UNITED STATES  
NUCLEAR REGULATORY COMMISSION  
WASHINGTON, D. C. 20555

December 2, 1992

SUBJECT: ZION STATION, UNITS 1 AND 2, FRACTURE TOUGHNESS REQUIREMENTS FOR  
PROTECTION AGAINST PRESSURIZED THERMAL SHOCK EVENTS, 10 CFR 50.61  
(TAC NOS. MB4546 AND MB4547)

Figure 1. Plot of Residual versus Fluence for Westinghouse with B&W Supplier

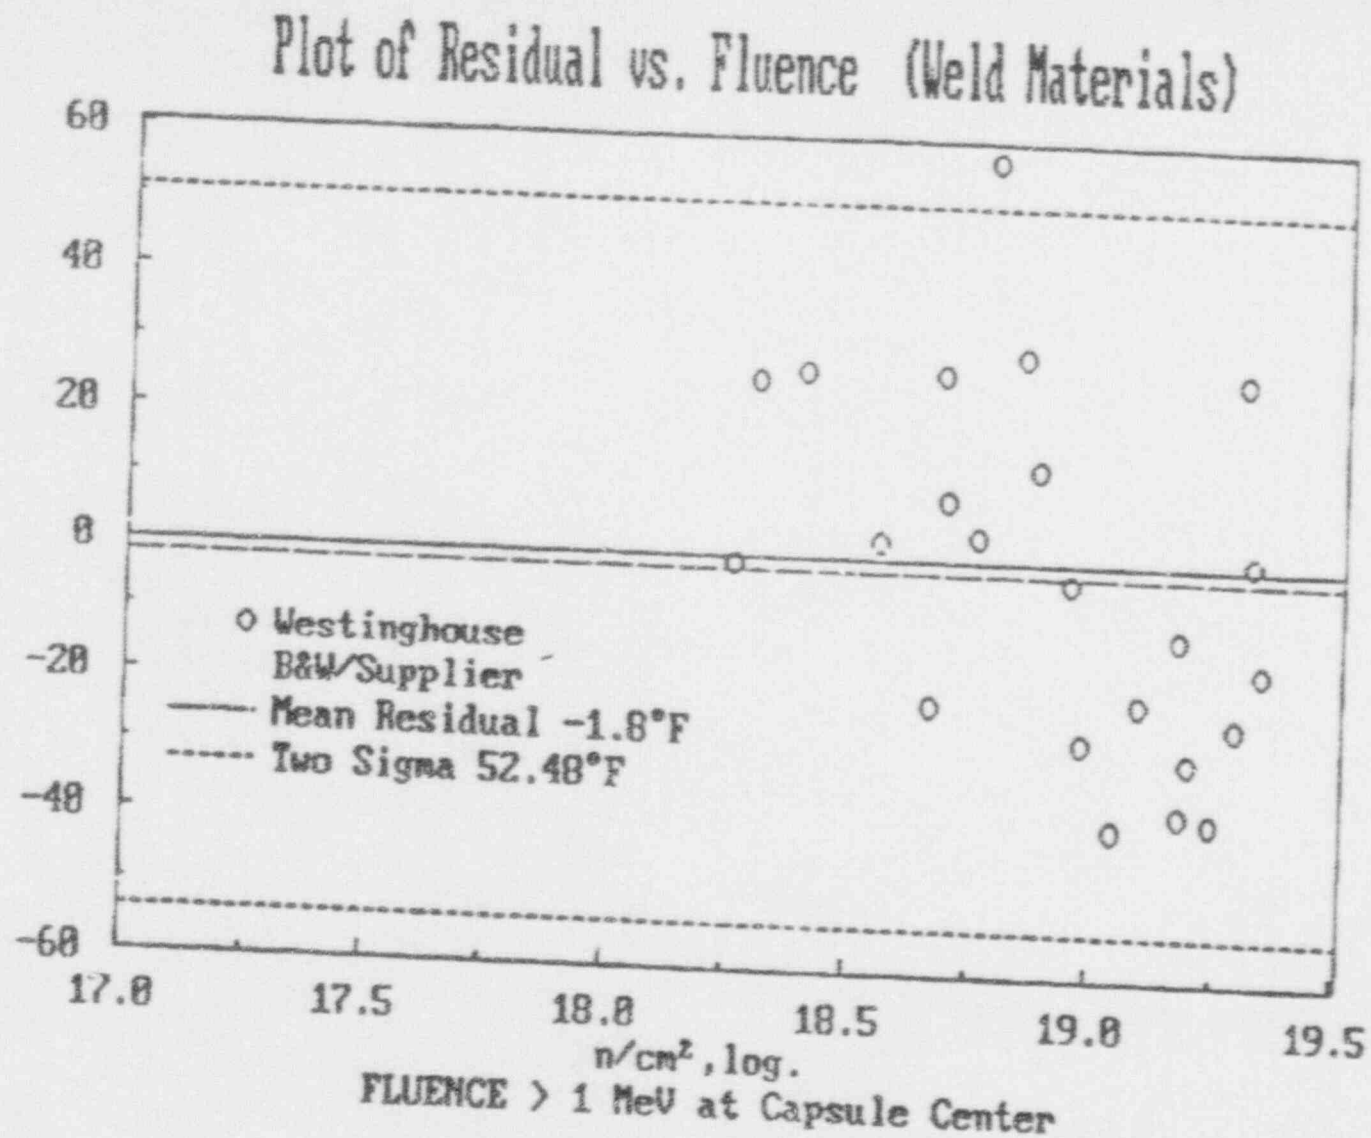
In this category, only the weld materials are available from PR-EL-9. A residual plot was generated for this category, the mean residual value (-1.8°F) and two sigma bounds (52.48°F) were also marked in the plot, see Figure 1. The residual plot could be interpreted to show a fluence dependence effect. At relative low fluences, say below  $10^{18}$  nvt, Reg. Guide 199 underpredicted the shift value, and at fluences greater than  $1.0 \times 10^{18}$  nvt, Reg. Guide 199 overpredicted the shift value.

Figure 2. Plot of Residual versus Fluence for Westinghouse SHSS02 Material

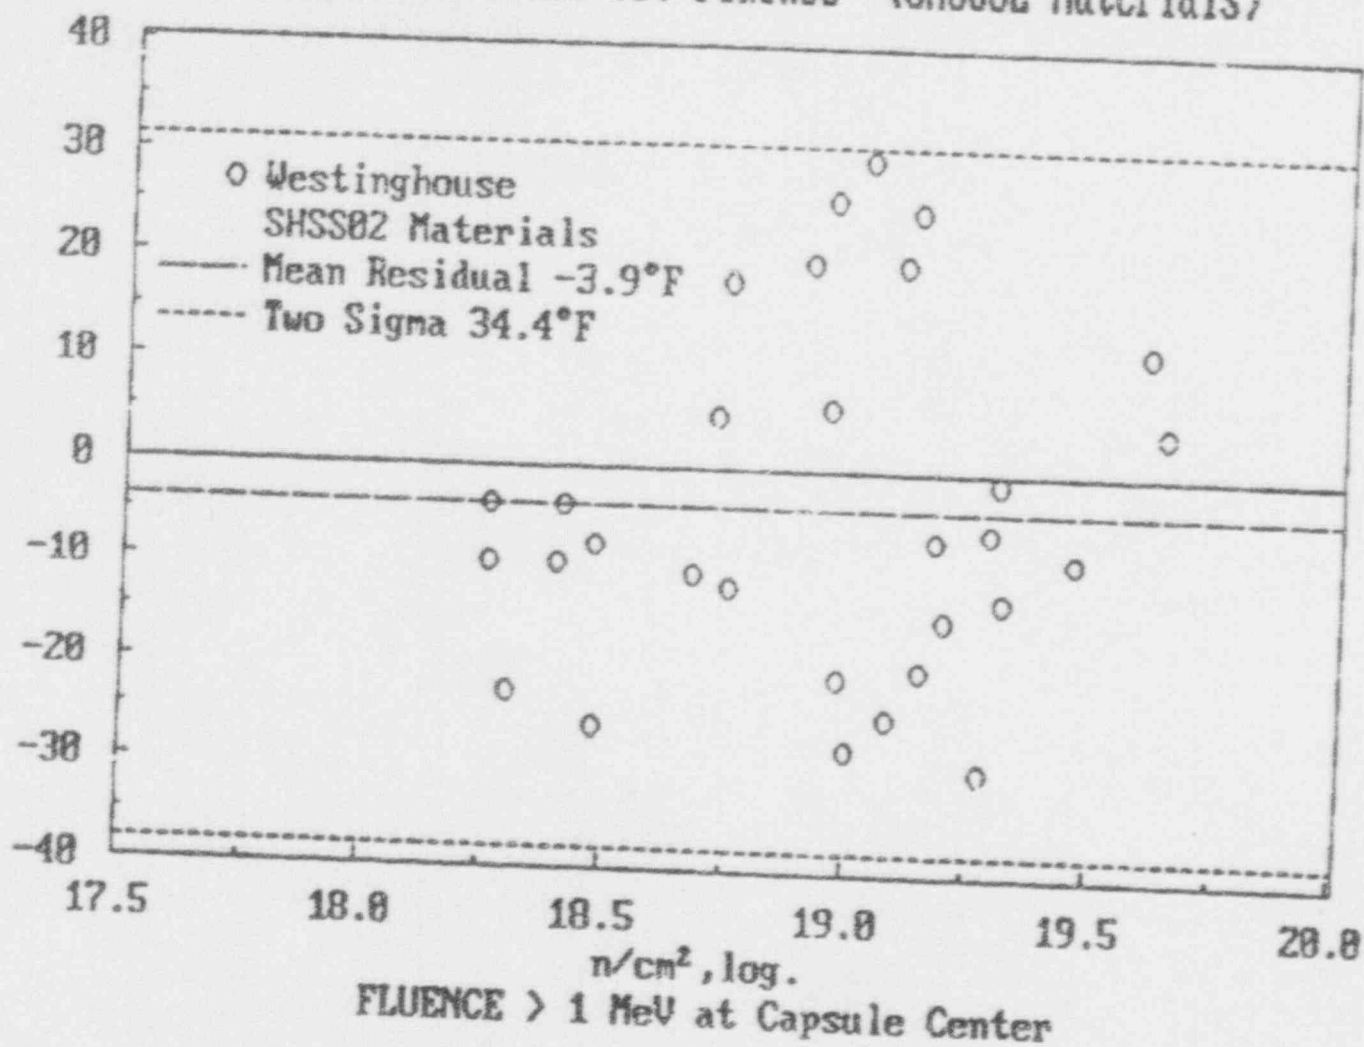
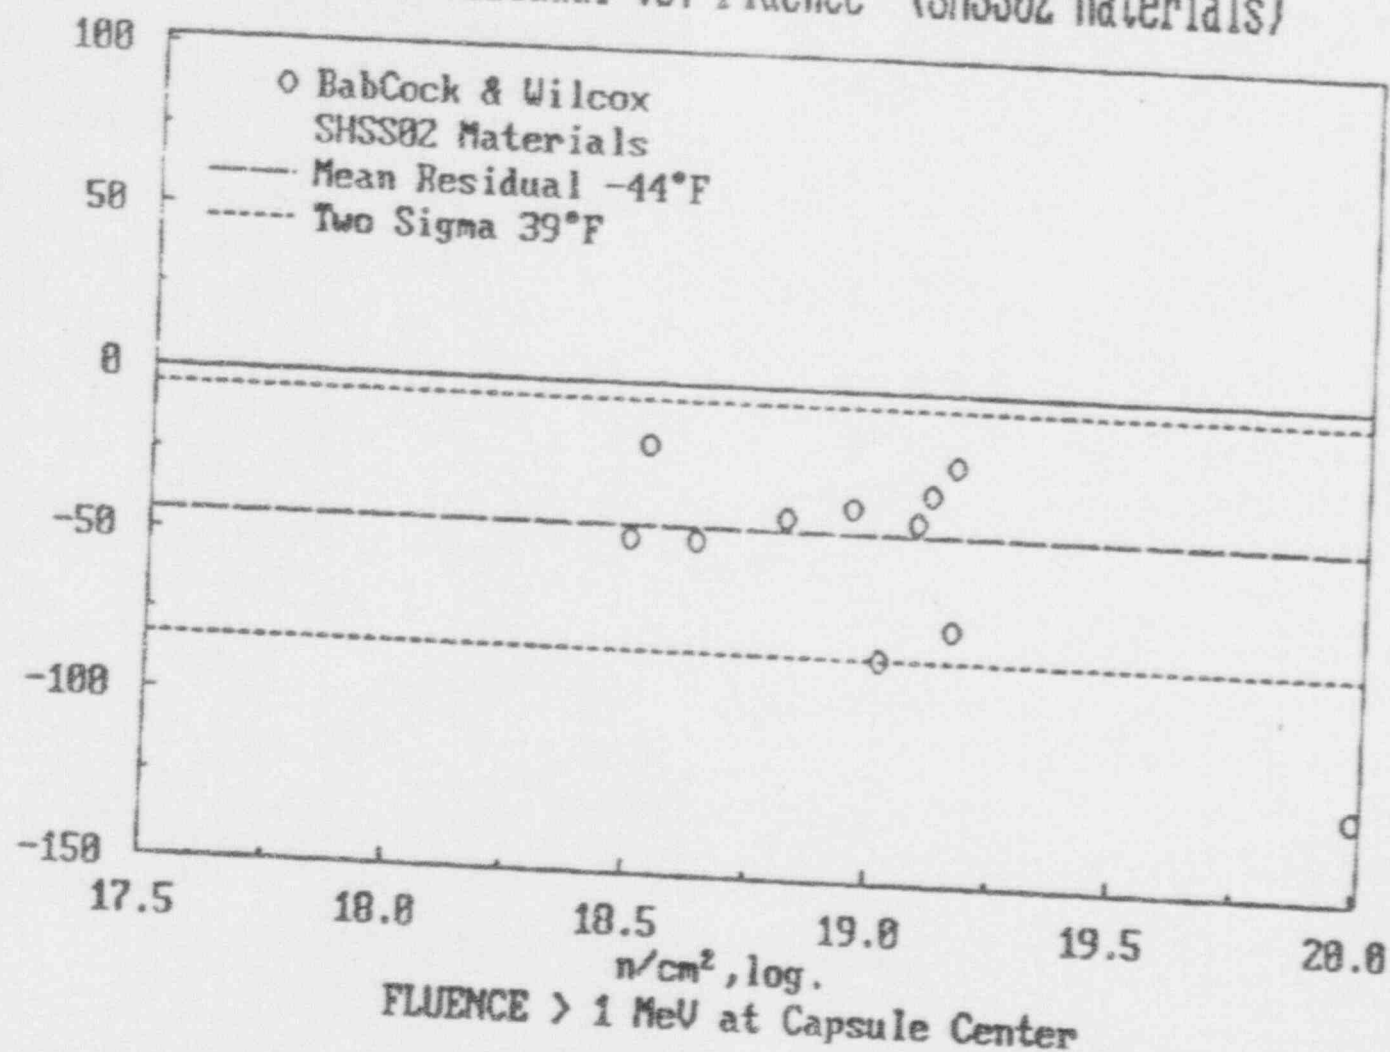
In this category, only the surveillance data of the standard reference material, SHSS02 (HSST02), is available for both Westinghouse and B&W plants from PR-EDB. Two residual plots, figure 2-3, were generated for Westinghouse and B&W respectively. The corresponding mean residual and two sigma bounds are listed below:

Vendor	Mean $\pm$ Two Sigma
Westinghouse	-3.90 $\pm$ 34°F
Babcock & Wilcox	-44.18 $\pm$ 39°F

Figure 4. Plot of Residual versus Fluence for B&amp;W Base Materials

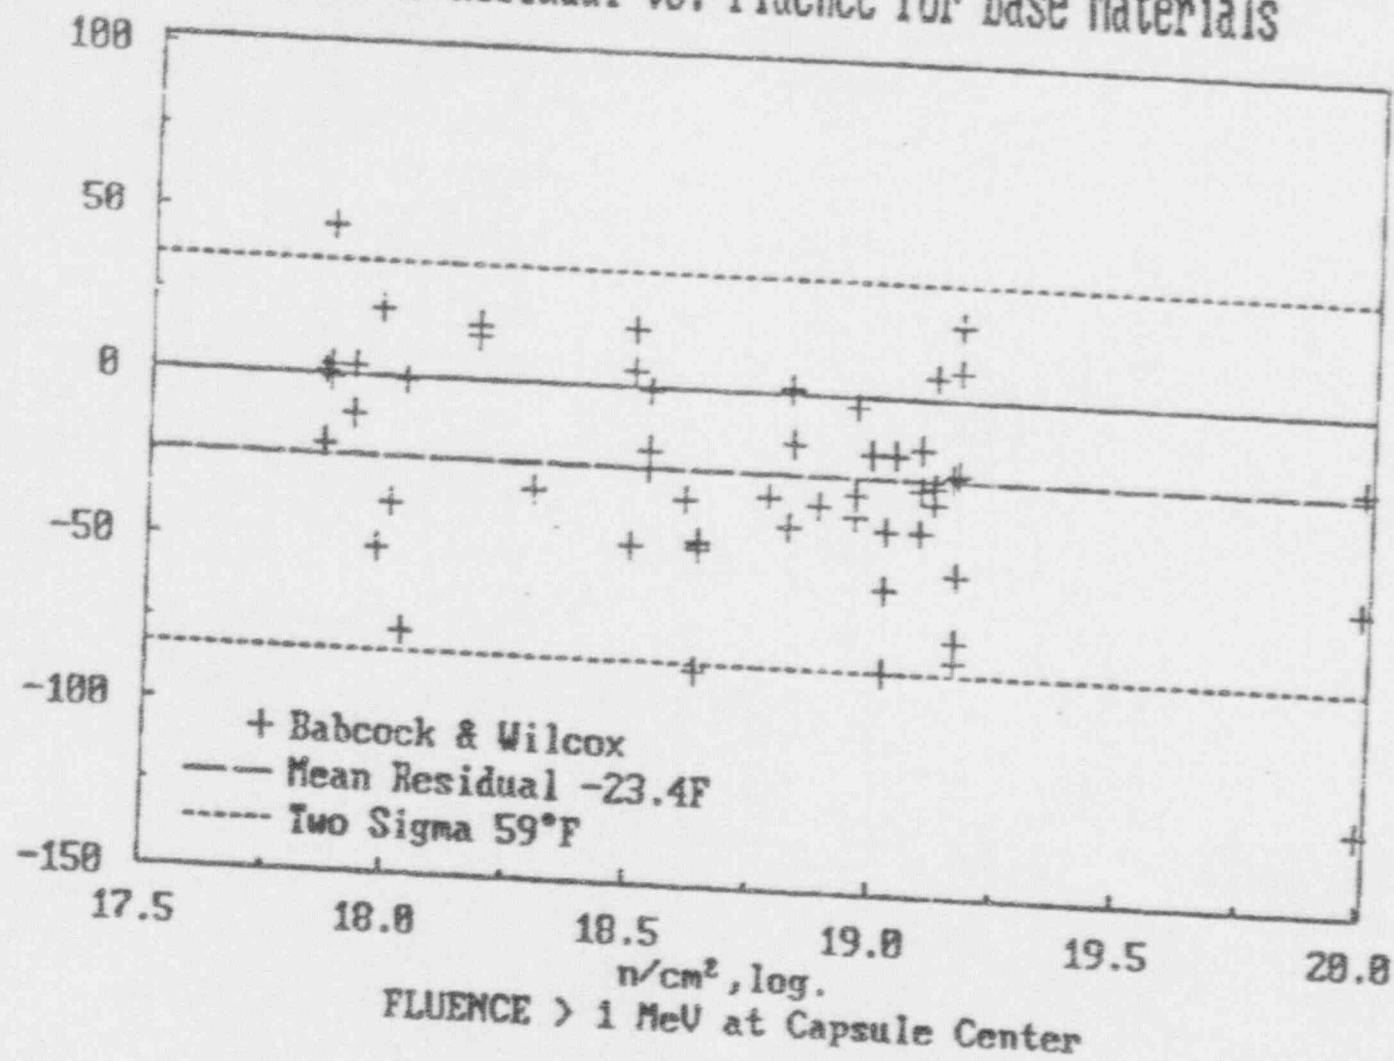
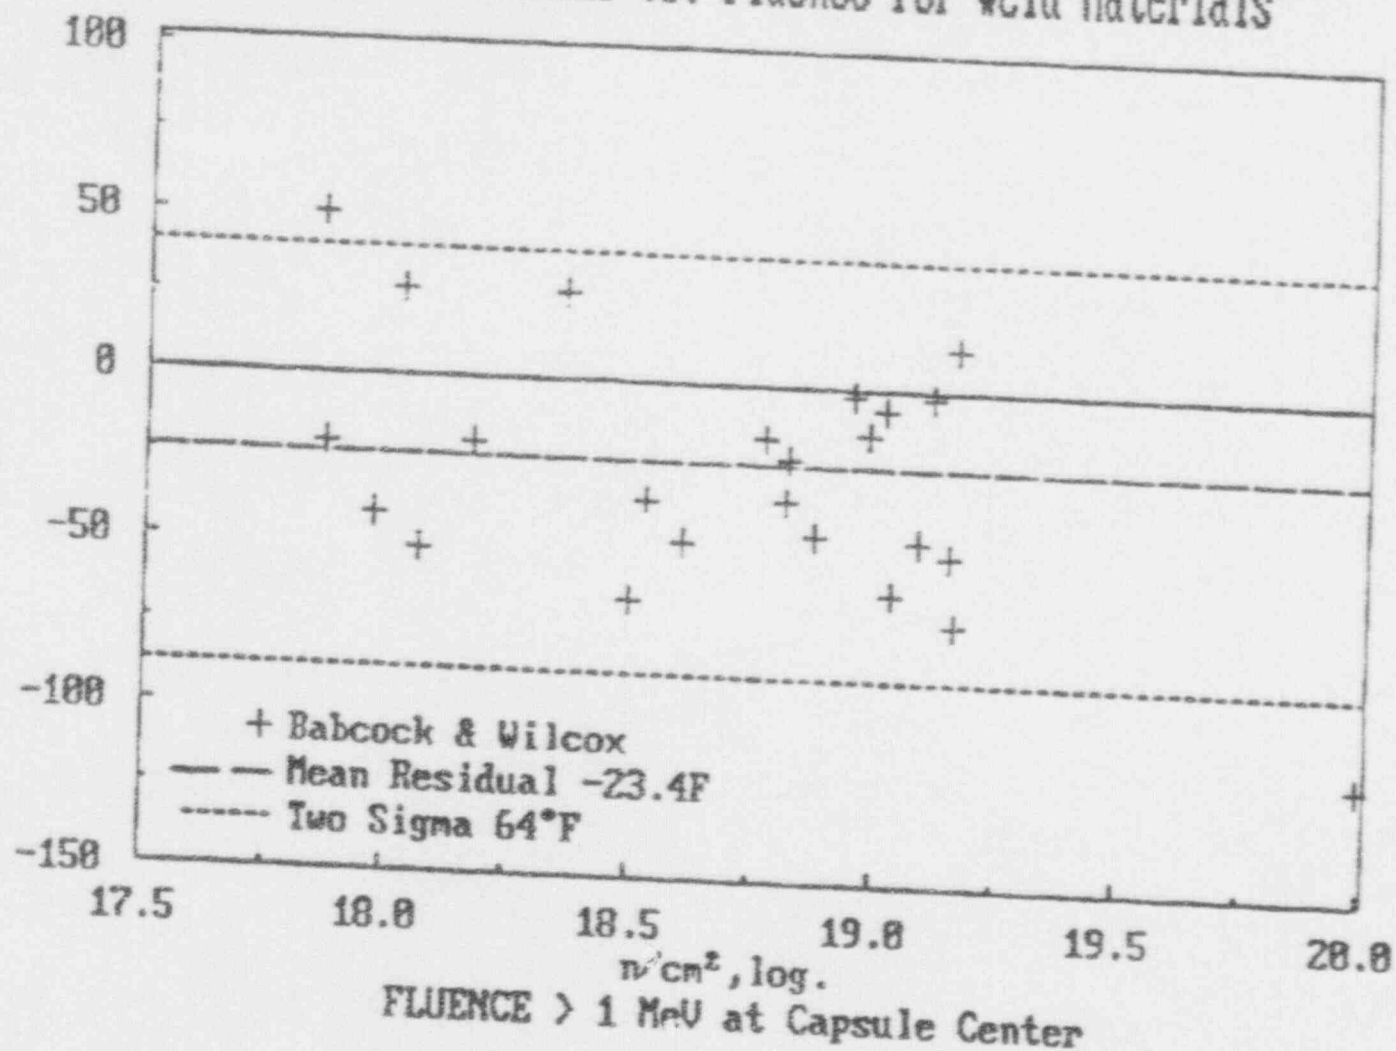
Two additional plots for B&W's base and weld materials are also included with this report. Both base and weld materials have -23°F mean residual, see figure 4-5. The Charpy specimens of different materials are distributed evenly within the B&W's surveillance capsule.
